## Application for Works Approval

<b>Works Approval Number</b>	W6913/2024/1
<b>Applicant</b>	BGC (Australia) Pty Ltd
<b>ACN</b>	005 736 005
<b>File number</b>	DER2024/000069
<b>Premises</b>	Midland Brick Caversham 29 Harper Street CAVERSHAM WA 6055  Part of Lot 2984 on Plan 202244, Lot 2985 on Plan 202244
<b>Date of report</b>	26 February 2025
<b>Decision</b>	Works approval granted

**Figure 3: Stormwater management layout of basins**

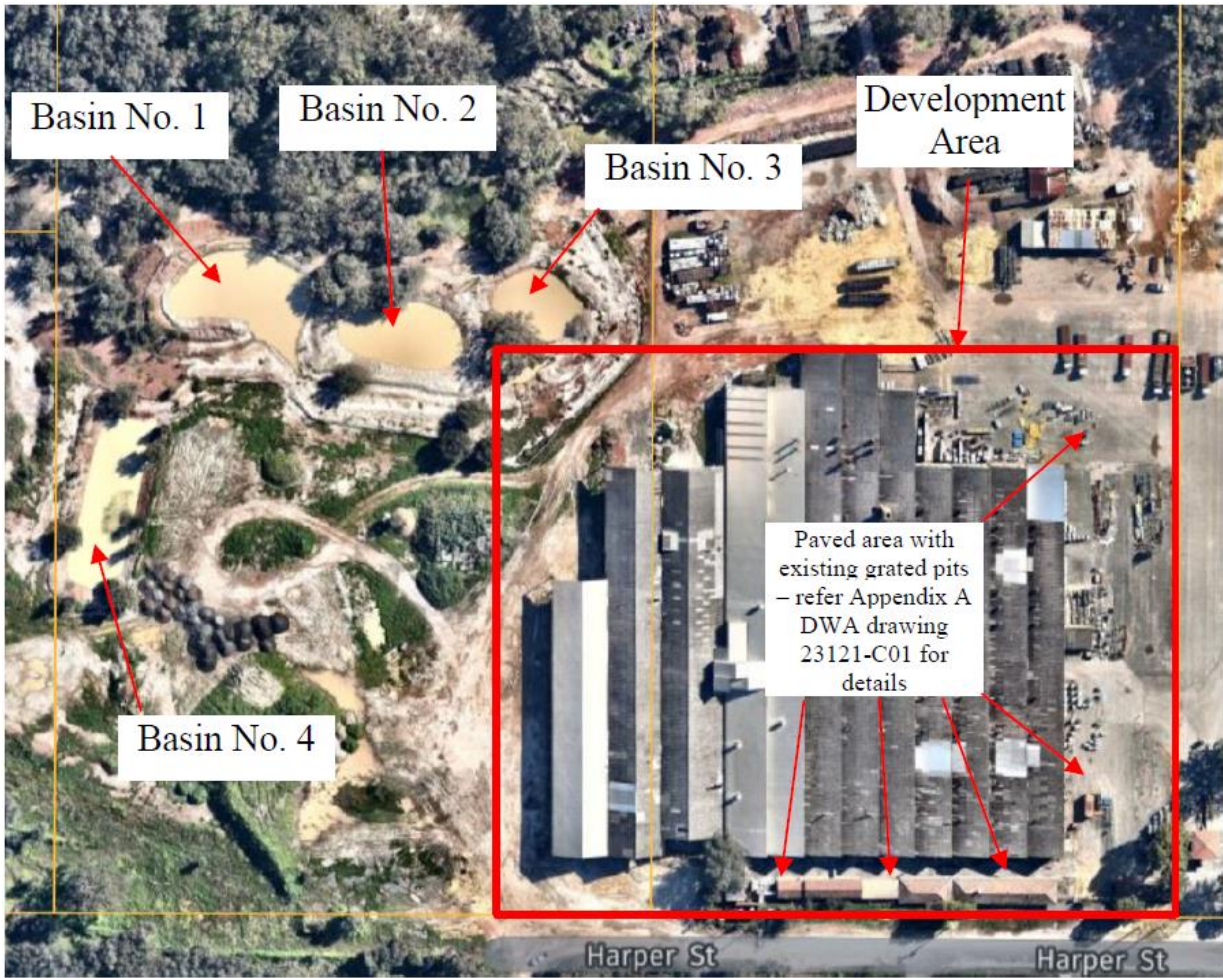
The department reviewed the Stormwater Management Plan provided with the application and upon review, required the applicant to revise the plan to address the below concerns:

- The premises has (and will continue to) discharge highly turbid stormwater into the adjacent waterway. This is not considered acceptable and would be contrary to the Stormwater Management Manual (DWER, 2004), and State Planning Policy 2.9 – *Water Resources, and water sensitive urban design*. The significance of the turbidity issue is evident from aerial photography.

- The Stormwater Management Plan contains virtually no information on water quality management. The applicant must identify the source of turbidity, why the stormwater settling basins (which are stated as “the interconnected basin system allows suspended solids to settle out”) appear to be highly turbid, and what structural and non-structural actions will be undertaken to resolve this turbidity.

- Aerial photography appears to show a significant amount of sediment build-up in the adjacent waterway/wetland area that is potentially from this site. The department would not support the discharge of any stormwater from this site until a satisfactory management plan has been provided.

- The Department’s Stormwater Management Manual (DWER, 2004) provides sufficient options for the management of turbid stormwater, although depending on the source of the turbidity may require additional management options. This is further complicated by the proposal to decommission Basin 4 which appears to be necessary to manage turbidity.

The applicant, with the above comments from the department and additional input provided to them from the Department of Biodiversity, Conservation, and Attraction (DBCA), responded by providing an updated Stormwater Management Plan, as well as providing a Drainage and Stormwater Monitoring and Maintenance Plan (DSWMMP). The DSWMMP addressed the issue of existing sediment build up in the basins by removing sediment from the basins and swales yearly in summer months, and as required. The sediment will be placed in the crushed material bay to be mixed through for production of recycled backing blocks. DBCA also supported the Stormwater Management Plan. Stormwater controls are discussed further in Section 3.1.1.
